## T echnical T ip

FILE	TAOSC-TT-20050308-01
DATE	08 February 2005

<b>PRODUCT</b>	CTV & PJTV
<b>Part No:</b>	Scan Module MDFS03 ( 23148027 )

### Another countermeasure

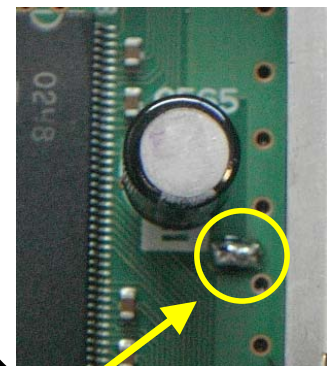
Symptom: Distortion or white peak noise appear on the screen

Cause : Poor ground at capacitor C565

Remedy: Solder the point refer to the attached Picture
